Beaches Link and Gore Hill Freeway Connection

Submission on Environmental Impact Statement (EIS)

Willoughby City Council – March 2021

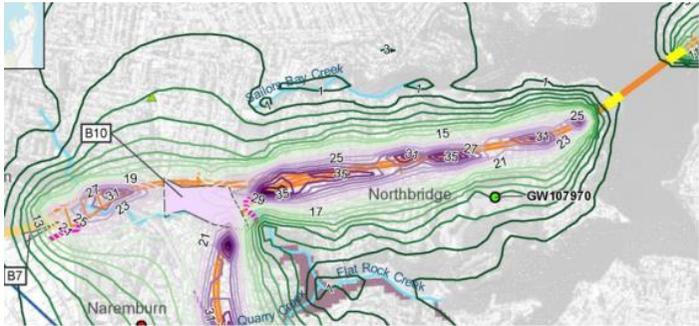
<p>borne vibration(s) to mitigate the risk to and potential damage to Clive Park including aboriginal shelters, caves, Aboriginal carvings and community pool artefacts.</p> <p>(CP-07) Construction methods to reduce reliance on blasting activities to mitigate the risk to and potential damage to Clive Park.</p> <p>(CP-08) the construction methods must reduce vibration and adopt the least impact alternative resulting from construction and received at any structure and/or heritage assets or artefacts, and shall be limited to:</p> <ul style="list-style-type: none">(a) For structural damage vibration, the highest asset protection elements of – the acceptable vibration values set out in the German Standard DIN 4150: Part 3- 1999 ‘Structural Vibration in Buildings: Effects on Structures’ and/or British Standard BS 7385-2:1993 ‘Evaluation and measurement for vibration in buildings. Guide to damage levels from ground-borne vibration’; and(b) For human exposure to vibration - the acceptable vibration values set out in the ‘Assessing Vibration: A Technical Guideline’ (DEC 2006); <p>(CP-09) Wherever practical, the Proponent shall undertake piling activities using non-percussive piles; and</p> <p>(CP-10) Wherever practical, the Proponent shall undertake all relevant construction activities with the objective of not exceeding the following ground-borne noise criteria at community facilities (including adjacent boat sheds) and residential receivers:</p> <ul style="list-style-type: none">a) an internal LAeq(15min) of 40 dB(A) between 6:00 pm and 10:00 pm; andb) an internal LAeq(15min) of 35 dB(A) between 10:00 pm and 7:00 am.

<p>(CP-11) The Proponent is to develop and implement all reasonable and feasible noise and vibration mitigation measures with the aim of minimising ground-borne noise and vibration impacts to Clive Park and at adjacent community facilities.</p> <p>(CP-12) The Proponent is to take all reasonable steps so as not to harm, modify or otherwise impact any Aboriginal areas and artefacts associated, except as authorised by the Minister of Planning.</p> <p>A condition of any approval be included requiring TfNSW to liaise with Heritage NSW, the Metropolitan Aboriginal Land Council and any other relevant stakeholders to address any impacts on Aboriginal cultural heritage.</p>
--	--	---------------------------------------------------------------------------------------------------------------------------------------------------------------------------------------------------------------------------------------------------------------------------------------------------------------------------------------------------------------------------------------------------------------------------------------------------------------------------------------------------------------------------------------------------------------------------------------------------------------------------------------------------------------------------------------------------

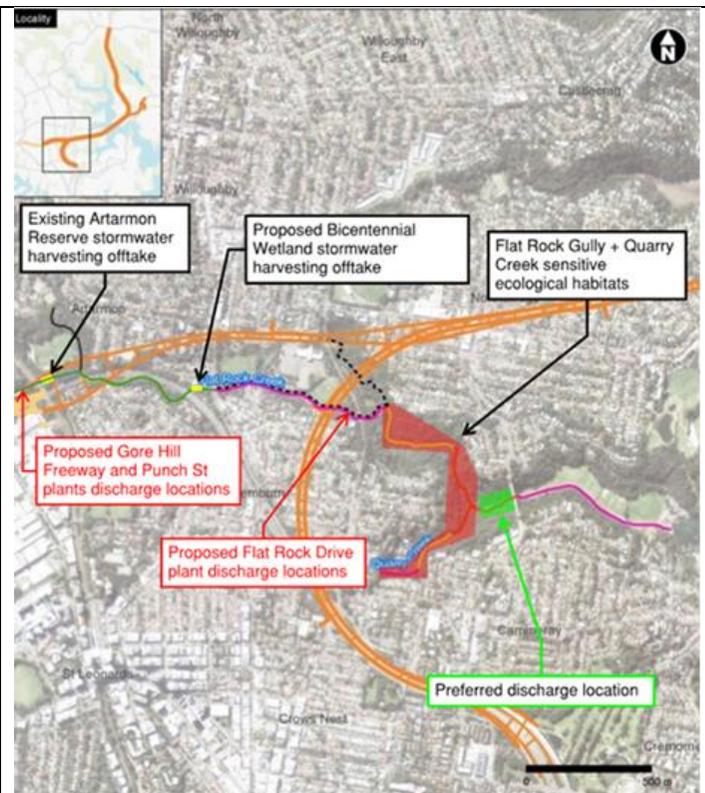
There are two major parameters of concern in regard to the discharge:

3. Salinity
4. Total Dissolved Solids

It is assumed that the discharge from the waste water plants will be saline based upon the following reasons:
